PCN: V16-006-E47540-MAA

Product Change Notice

Description and Extent of Change:
MPO port plug change of transceiver modules.

Current MPO Port Plug + CXP Module

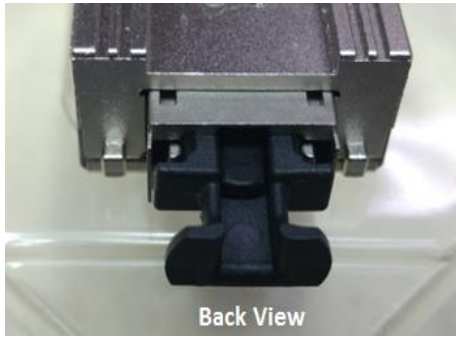
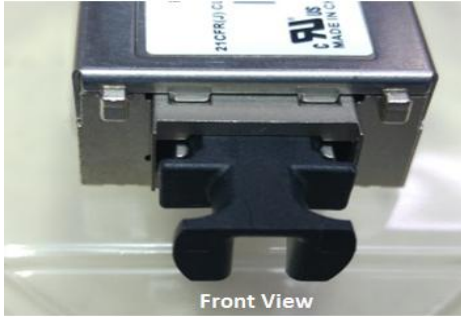
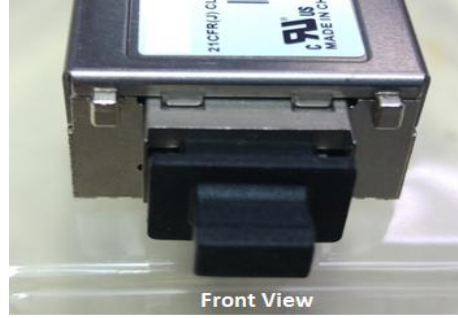
New MPO Port Plug + CXP Module

Current MPO Port Plug + QSFP+ 25G Module

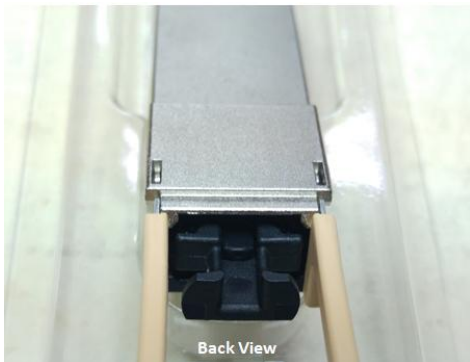
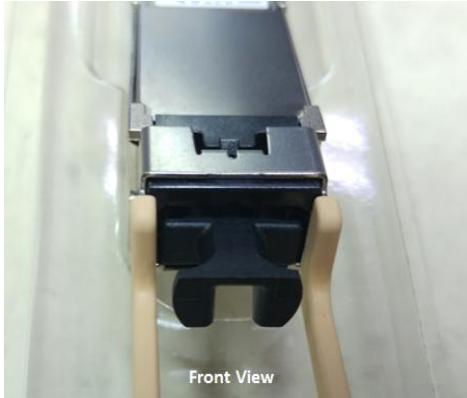
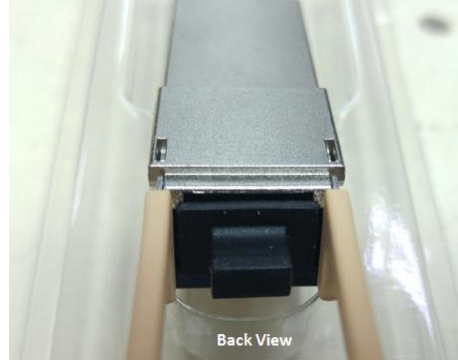
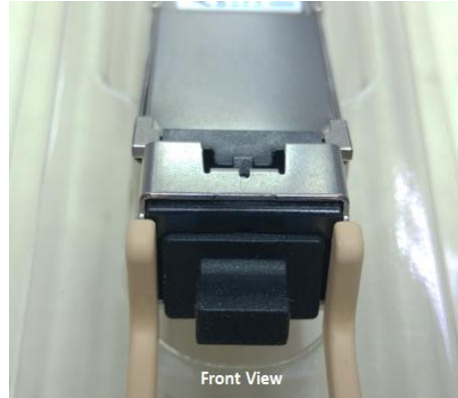
New MPO Port Plug + QSFP+ 25G Module

Current MPO Port Plug + QSFP+ 40G bail de-latch Module

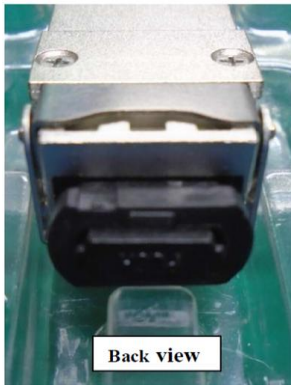
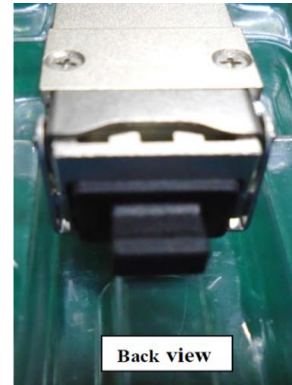
New MPO Port Plug + QSFP+ 40G bail de-latch Module

Current MPO Port Plug + QSFP+ 40G pull tab Module

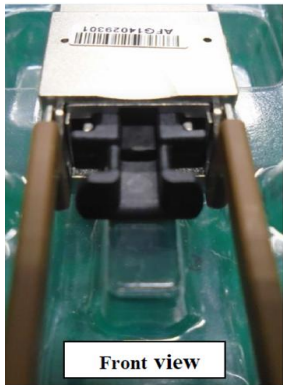
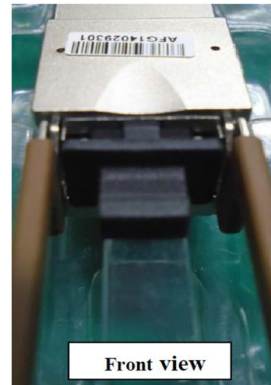
New MPO Port Plug + QSFP+ 40G pull tab Module
